B1417 Hartford End, Chelmsford, Essex

Proposed Site Access and Off Site Highway Improvements

Stage 1 Road Safety Audit

Report title	B1417 Hartford End, Chelmsford, Essex Proposed Site Access and Off Site Highway Improvements Stage 1 Road Safety Audit
Date	14 th September 2023
Document reference and revision	ATC/860/ITL/1 Rev 1
Prepared by	Allen Transport Consultancy Ltd
On behalf of	Intermodal Transportation Ltd

Drawing Title:
**PROPOSED SITE ACCESS, BUS
STOP AND CROSSING
POINT LAYOUT**

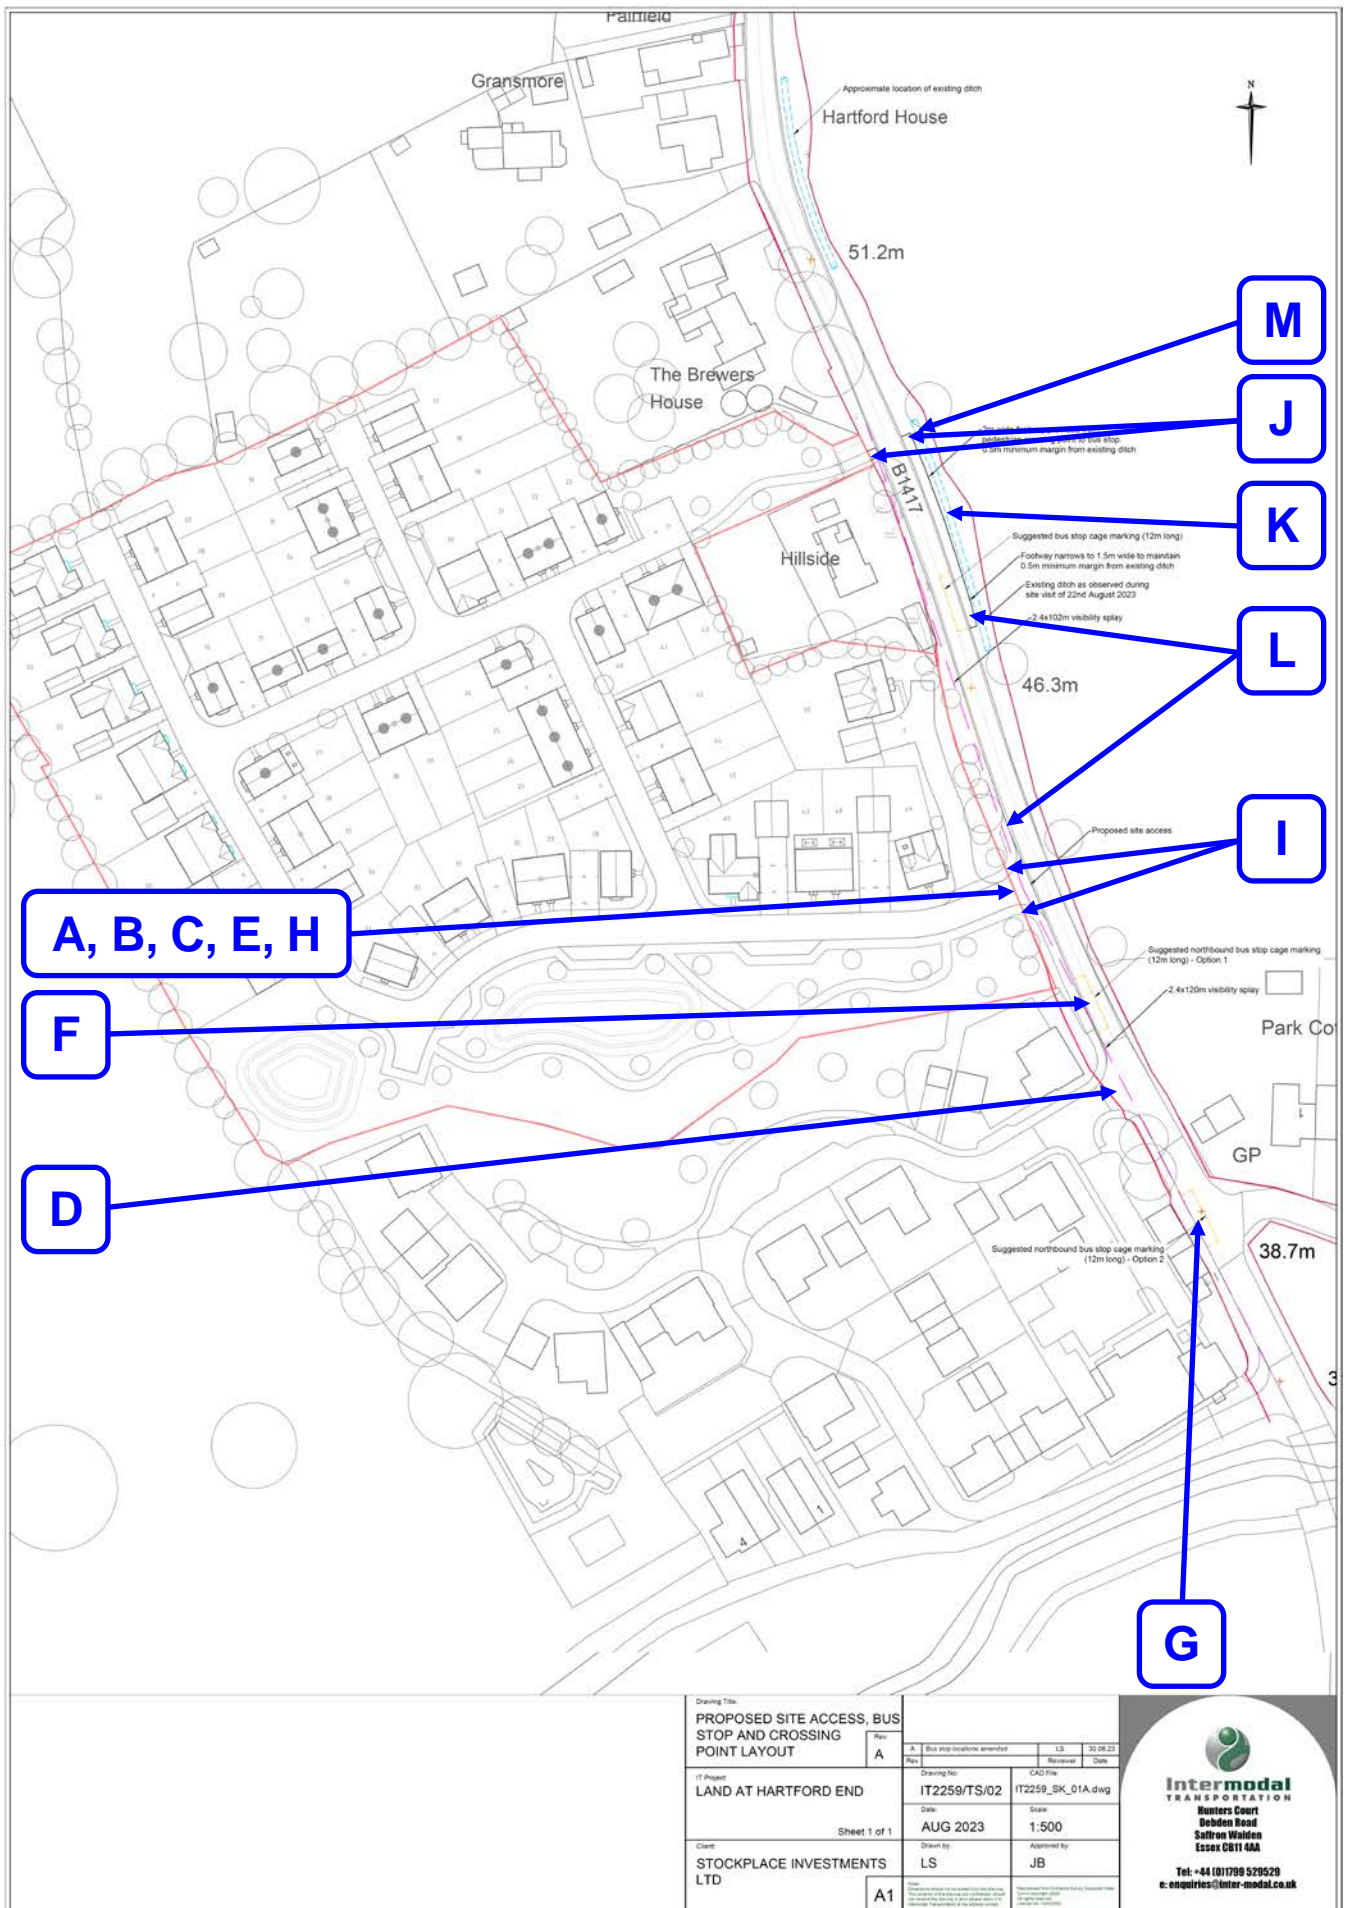
Location: A – Development site access junction (Drawing No: IT2259-TS-02).

Summary: Existing telegraph pole located near the proposed access junction could result in a potential increased risk of vehicles striking the telegraph pole or vehicular and pedestrian collisions occurring, whereby vehicle occupants and pedestrians could sustain personal injury.

Concern arises that the location of the existing telegraph pole may impact upon the operation of the proposed access junction. As a result, this situation could lead to a potential increased risk of vehicles striking the telegraph pole when manoeuvring within the access junction, whereby vehicle occupants could sustain personal injury.

Additionally, concern arises that the existing telegraph pole may impact upon the available width of the proposed western footway, which could result in pedestrians having to step out into the northbound carriageway in order to pass one another. As a result, this situation could lead to a potential increased risk of vehicular and pedestrian collisions occurring, whereby pedestrians could sustain personal injury.

Location: B – Development site access junction (Drawing No: IT2259-TS-02).

Summary: Potential vertical alignment issues at the proposed site access junction with the B1417 Hartford End could result in a potential increased risk of side impact vehicular collisions occurring, whereby vehicle occupants could sustain personal injury.

Concern arises that due to the identified difference in levels, vehicular traffic could inadvertently roll forward into the B1417 Hartford End carriageway when giving way to vehicular traffic on the B1417 Hartford End. This situation could lead to a potential increased risk of side impact vehicular collisions occurring between vehicles emerging from the access road junction and northbound vehicular traffic, whereby vehicle occupants could sustain personal injury.

Locations: **C** and **D** – Development site access junction (Drawing No: IT2259-TS-02).

Summary: Location of the proposed access junction in relation to Ridley Green could increase the potential risk of side impact collisions occurring, whereby vehicle occupants could sustain personal injury.

Concern arises that vehicular traffic heading northbound on the B1417 Hartford End and indicating left to turn into proposed development site, may result in right turning vehicular traffic pulling out of the Ridley Green junction, as drivers may incorrectly assume the left turning vehicle will be turning into the Ridley Green junction.

Summary: Restricted visibility could result in a potential increased risk of side impact collisions occurring, whereby vehicle occupants could sustain personal injury.

The scheme drawing indicates that a new access junction is proposed on the western side of the B1417 Hartford End. The scheme drawing also indicates visibility splays of 2.4 x 120m to the south and 2.4m x 102m to the north, whereby the northern visibility splay is in accordance with a speed survey undertaken in June 2021.

Concern arises that restricted visibility for drivers emerging from the proposed access junction could lead to a potential increased risk of side impact collisions occurring, between drivers emerging from the development site and southbound vehicular traffic on the B1417 Hartford End, whereby vehicle occupants could sustain personal injury.

Locations: F and G – Development site access junction and Ridley Green access junction (Drawing No: IT2259-TS-02).

Summary: Stationary buses located within the either of the proposed northbound bus stop locations impact upon the visibility splays between drivers emerging from either the proposed access junction or the existing Ridley Green junction and vehicular traffic on the B1417 Hartford End. This situation could result in a potential increased risk of side impact collisions occurring, whereby vehicle occupants could sustain personal injury.

Concern arises that when occupied both the proposed northbound bus stop location options impact upon the visibility splays of the proposed access junction and the existing adjacent Ridley Green junction.

Location: H – Development site access junction (Drawing No: IT2259-TS-02).

Summary: Potential swept path requirements of vehicles entering and exiting the proposed development site access junction could result in a potential increased risk of head or side swipe type collisions occurring, whereby vehicle occupants could sustain personal injury.

Concern arises that the potential swept path requirements of vehicles entering and exiting the proposed development site access junction, including refuse vehicles, supermarket delivery vehicles and long wheel base panel vans may cross the centre lines within the proposed access junction and the centre lines on the B1417 Hartford End. As a result, this situation could lead to a potential increased risk of head on or side swipe type collisions occurring between opposing flows of vehicular traffic, whereby vehicle occupants could sustain personal injury.

Location: I – Development site access junction (Drawing No: IT2259-TS-02).

Summary: Assumed kerb heights could result in a potential increased risk of pedestrian trips and falls occurring, especially for those pedestrians who are blind, visually or mobility impaired, whereby pedestrians could sustain personal injury.

It is noted from the scheme drawing that dropped kerbs have not been indicated across the proposed access junction. As a result, concern arises that pedestrians negotiating the assumed full height kerbs at this location could lead to a potential increased risk of pedestrian trips and falls occurring, especially for those pedestrians who may be blind, visually or mobility impaired, whereby pedestrians could sustain personal injury.

Location: J – Development site uncontrolled pedestrian crossing provision (Drawing No: IT2259-TS-02).

Summary: Potential restricted inter-visibility at the uncontrolled pedestrian crossing facility could result in a potential increased risk of vehicular and pedestrian collisions occurring, whereby pedestrians could sustain personal injury.

Concern arises that potential restricted inter-visibility between pedestrians crossing the B1417 Hartford End from east to west and vice-versa and vehicular and traffic on the B1417 Hartford End could lead to a potential increased risk of vehicular and pedestrian collisions occurring, whereby pedestrians could sustain personal injury.

Location: K – Proposed eastern footway (Drawing No: IT2259-TS-02).

Summary: An existing ditch is present near the proposed footway, which could result in a potential increased risk of pedestrian slips and falls occurring, especially during the hours of darkness at the B1417 is unlit, whereby pedestrians could sustain personal injury.

Concern arises that users of the proposed eastern footway could inadvertently trip, slip and fall into the adjacent ditch, especially during the hours of darkness, as the B1417 Hartford End is unlit, whereby pedestrians could sustain personal injury.

Location: L – Proposed eastern footway (Drawing No: IT2259-TS-02).

Summary: Lack of pedestrian continuity for pedestrians seeking to access the southbound bus stop could result in a potential increased risk of vehicular and pedestrian collisions occurring, whereby pedestrians could sustain personal injury.

Concern arises that whilst a footway provision is available for pedestrians seeking to access the proposed northbound bus stop, there is a lack of footway provision to the proposed southbound bus stop when walking northbound along the B1417 Hartford End, as the western footway ends to the immediate north of the proposed development site access junction. This results in pedestrians having to walk within the vehicular carriageway, as there is a lack of continuity of the footway network.

Location: M – Proposed eastern footway (Drawing No: IT2259-TS-02).

Summary: Existing telegraph pole located within the proposed eastern footway could result in a potential increased risk of vehicular and pedestrian collisions occurring, whereby vehicle occupants and pedestrians could sustain personal injury.

Concern arises that the existing telegraph pole may impact upon the available width of the proposed eastern footway, which could result in pedestrians having to step out into the southbound carriageway in order to pass one another. As a result, this situation could lead to a potential increased risk of vehicular and pedestrian collisions occurring, whereby pedestrians could sustain personal injury.

It is recommended that the existing telegraph pole should be annotated on the scheme drawing.

Should the existing telegraph pole impact upon the proposed access junction or proposed western footway, it is further recommended that the telegraph pole should be shown to be relocated.

It is recommended that a proposed dwell area / flat plateau should be provided where the access road junction meets the B1417 Hartford End carriageway. Ideally, the approach gradient of the access road should be 2% or a gradient of 1:50. Additionally, where possible, the design should seek to achieve a level section of at least 15m length adjacent to the B1417 Hartford End carriageway.

It is recommended that the location of the proposed access junction should be in line with Local Authority policies on junction spacing.

If for whatever reasons the above cannot be achieved, then it is recommended that approval for the current proposals should be sought and agreed with the Overseeing Organisation, i.e. the Local Highway Authority, Essex County Council.

It is recommended that the proposed visibility splay should be kept clear of any impediments in order to mitigate the above described potential collision scenario.

If for whatever reasons the above cannot be achieved, then it is recommended that approval for the current proposals should be sought and agreed with the Overseeing Organisation, i.e. the Local Highway Authority, Essex County Council.

It is recommended that either the northbound bus stop should be located outside the visibility splays for the proposed development site access junction and the existing junction of Ridley Green or a bus stop layby should be provided, in order to mitigate the above described potential collision scenario.

It is recommended that swept path analysis exercises should be undertaken in order to assist with the required geometry of the development site access junction.

Should the swept path analysis exercises indicate that the current access junction proposals impact upon the swept path requirements, whereby vehicular collisions could occur, then it is further recommended that the junction geometry should be modified, in order to mitigate the above described potential collision scenarios.

It is recommended that dropped kerbs and tactile paving should be provided across the access junction, in order to mitigate the above described potential injury scenario.

It is recommended that the inter-visibility should be kept clear of any impediments, in order to mitigate the above described potential collision scenario. This is likely to require the removal of existing vegetation.

It is recommended that suitable and adequate measures, such as fencing or a culvert, should be provided, in order to mitigate the above described potential injury scenario.

It is recommended that a continuous footway should be provided in order for local residents to access the southbound bus stop, without having to walk within the existing carriageway, in order to mitigate the above described potential collision scenario.

It is recommended that the existing telegraph pole should be annotated on the scheme drawing.

Should the existing telegraph pole impact upon the proposed eastern footway, it is further recommended that the telegraph pole should be shown to be relocated.
